Docket Items #6 & #7
BAR CASE # 2017-00475 &
2017-00476

BAR Meeting
February 7, 2018

ISSUE: Permit to Demolish/Capsulate for partial demolition, Certificate of Appropriateness for alterations and a Waiver of Rooftop HVAC Screening Requirement

LOCATION: 1006 King Street

1 1ST FLOOR — PROPOSED PLAN
1/16"=1'-0"

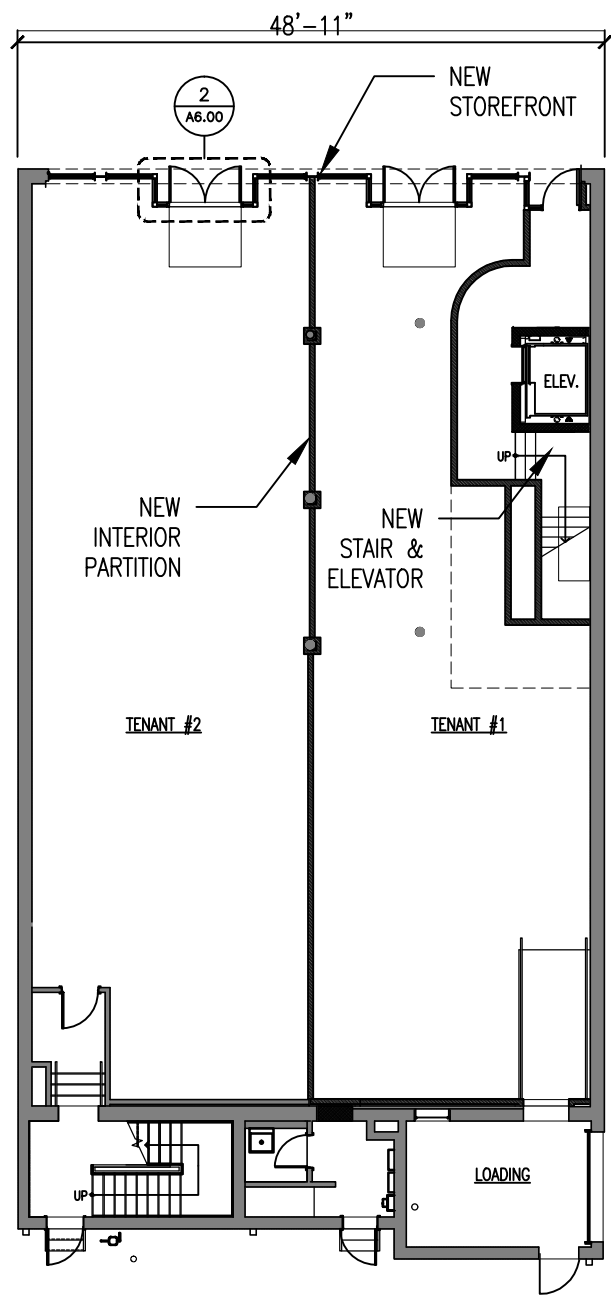
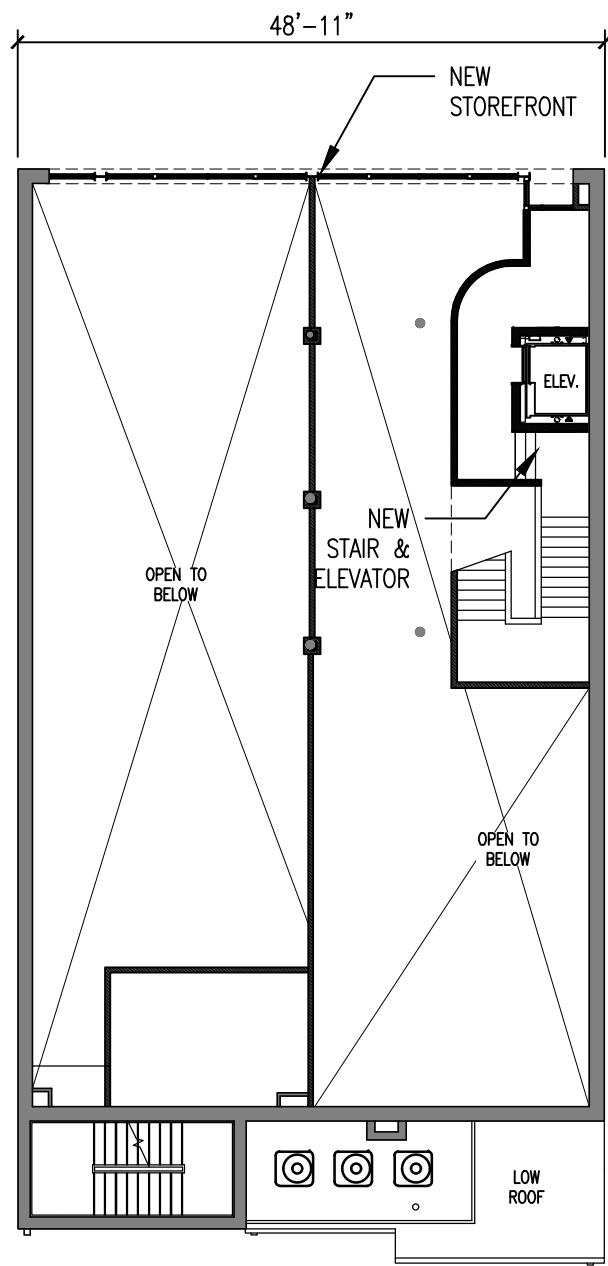
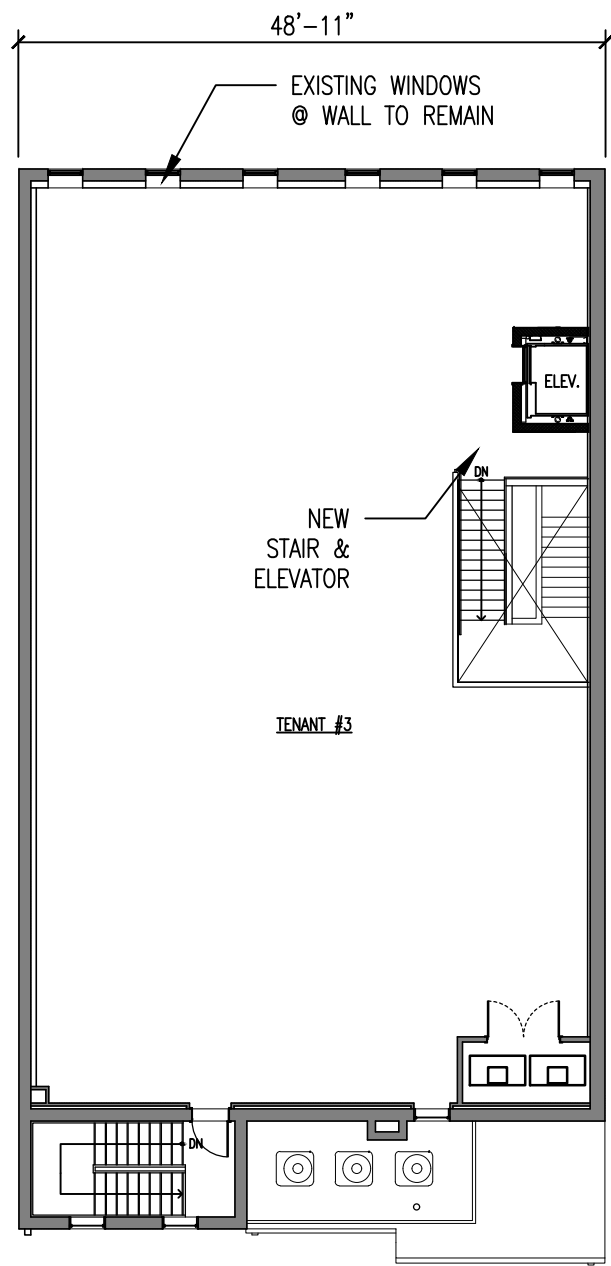
- C-1 Existing floor plan required
- C-2 Separate tenant spaces will require separate exits for each individual space. This will need to be indicated on plan.
- C-3 A building permit, plan review and inspections are required prior to the start of construction.

1 CROSS SECTION — NEW ROOF EQUIPMENT LOCATION
1/8"=1'-0"

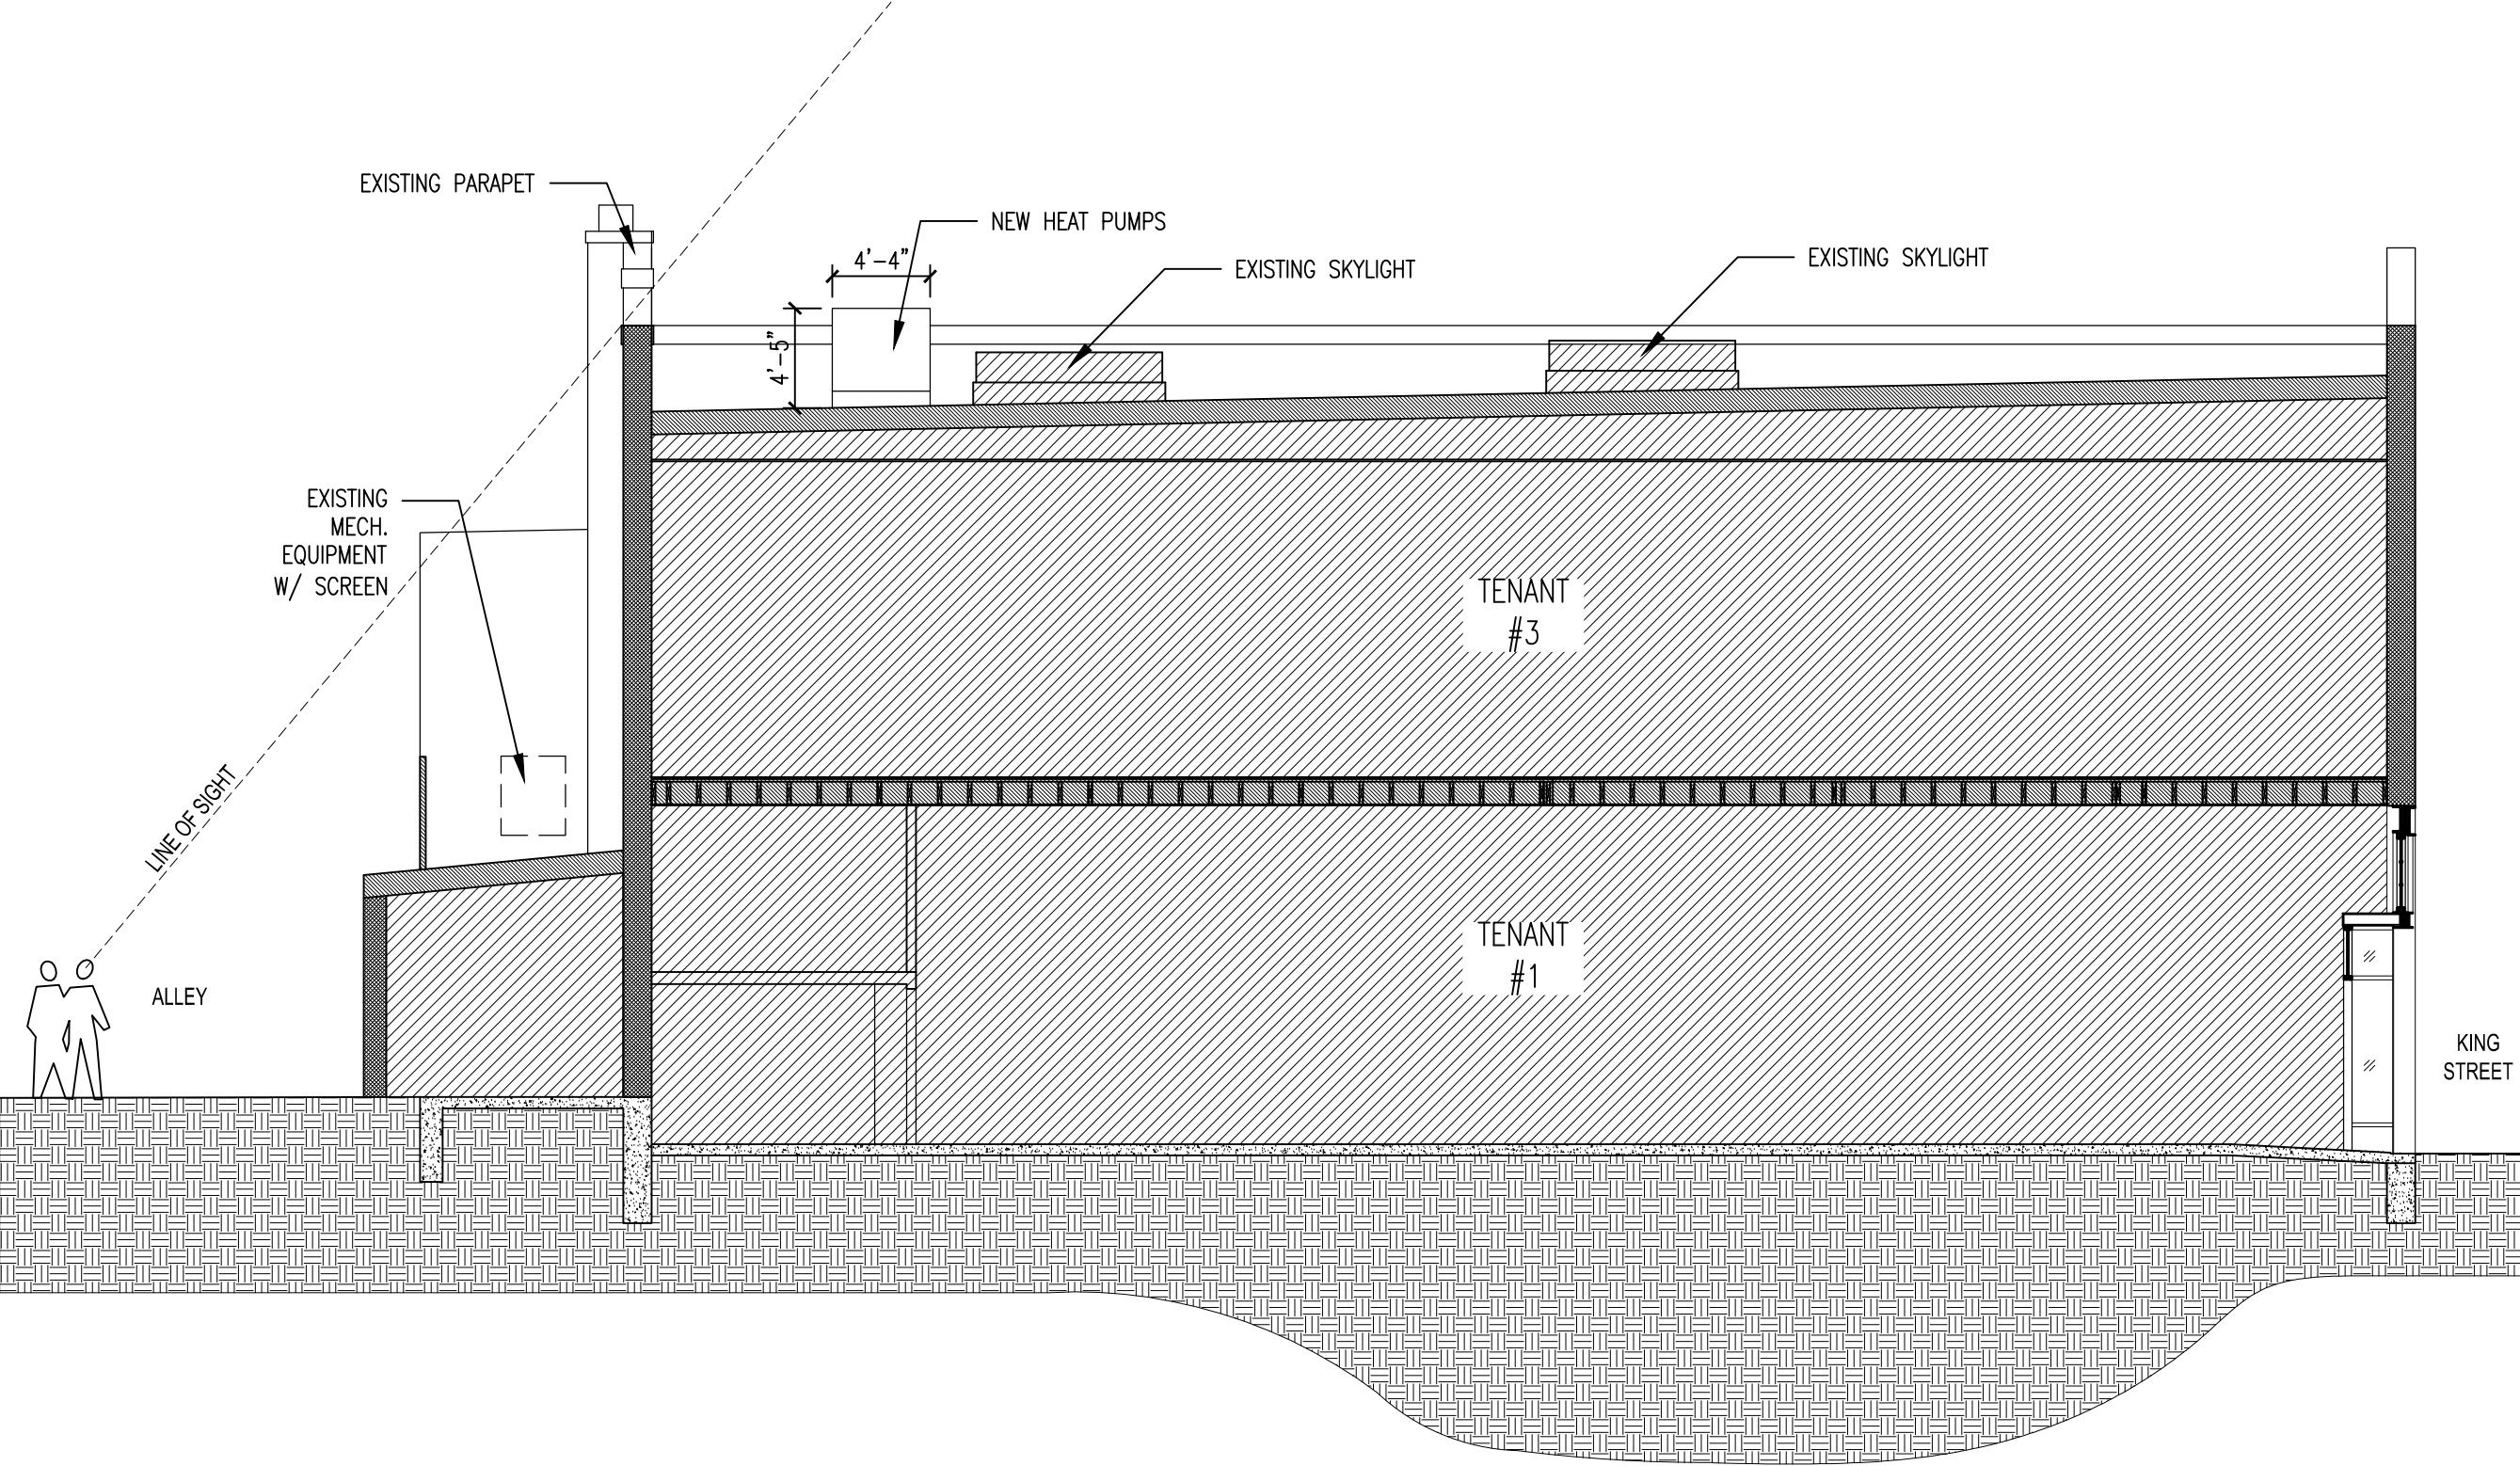
1. The final location of rooftop mechanical units must be determined in the field with staff to ensure they are in the best location to eliminate or minimize visibility.

In this case, the applicant has provided sight line graphics indicating that the new units on the roof of the primary structure will very likely not be visible, and certainly less than the existing units on the lower roof in the alley which have prominent screening. Therefore, staff supports the request to waive screening requirement for the rooftop units but recommends a condition that the final location of rooftop mechanical units must be determined in the field with staff to ensure they are in the best location to eliminate or minimize visibility.
